TECHNICAL SERVICE BULLETIN

Rubbing Noise At Front Of Vehicle While Driving And/Or DTCs C0031 And/Or C0034 - Built On Or Before 14-Jun-2021

22-2118

Ford 2021 F-150	Built on or before 14-June-2021
---------------------------	---------------------------------

Figure 1 - Correct routing

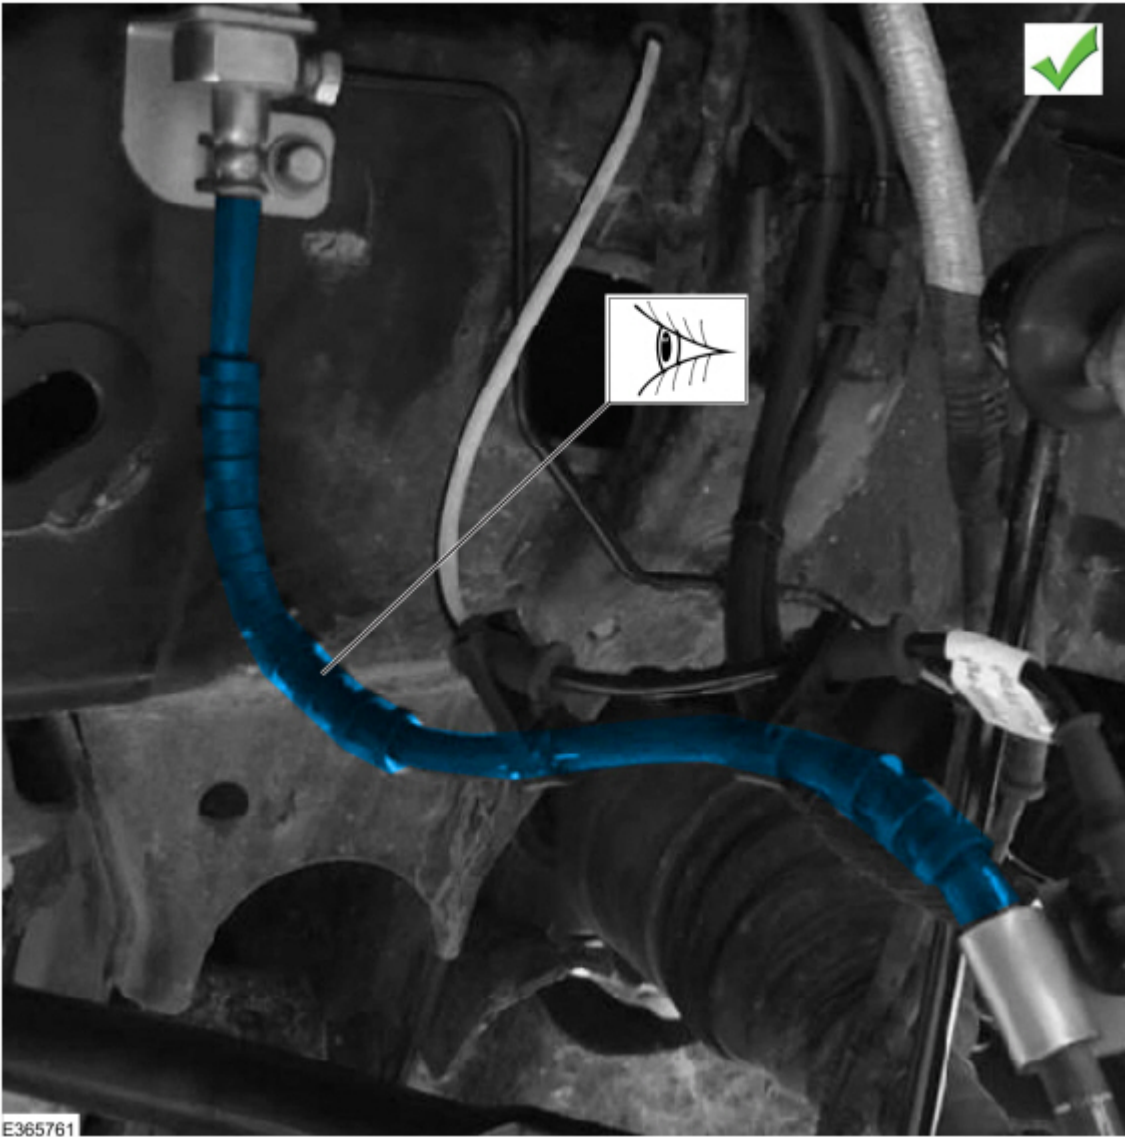
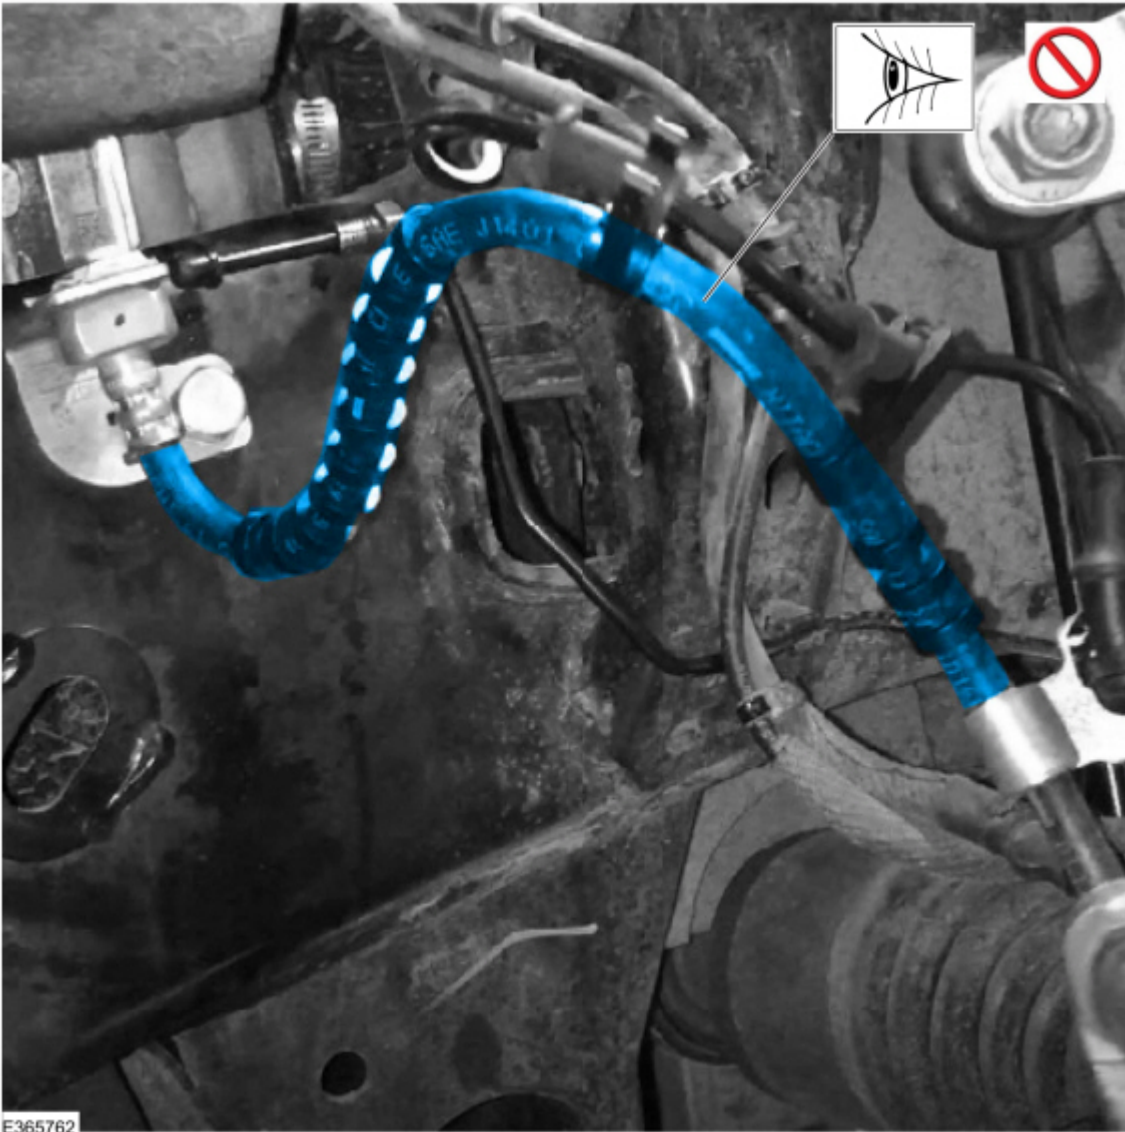
1. With the vehicle on the ground or a drive-on hoist and the steering wheel centered, inspect the routing of both front brake flexible hoses. (Figures 1-2)

NOTE: The flexible hoses must travel downward on the frame side before bending and bend near where they enter the bracket secured to the steering knuckle. There should be greater than 3/4 inch (19 mm) clearance between the brake flexible hose and the wheel/tire assembly.

2. Are both front brake flexible hoses routed correctly? (Figure 1)
 - (1). Yes - this article does not apply.
 - (2). No - proceed to step 3.
3. Replace the affected front brake flexible hose(s). Refer to Workshop Manual (WSM), Section 206-03. When installing the new hose(s), they must travel downward on the frame side before bending toward the steering knuckle and then bend near the bracket secured to the steering knuckle. (Figure 1)
4. Inspect the affected wheel speed sensor harness(es). Is the wheel speed sensor harness damaged?
 - (1). Yes - replace the affected wheel speed sensor.
 - (2). No - repair is complete.
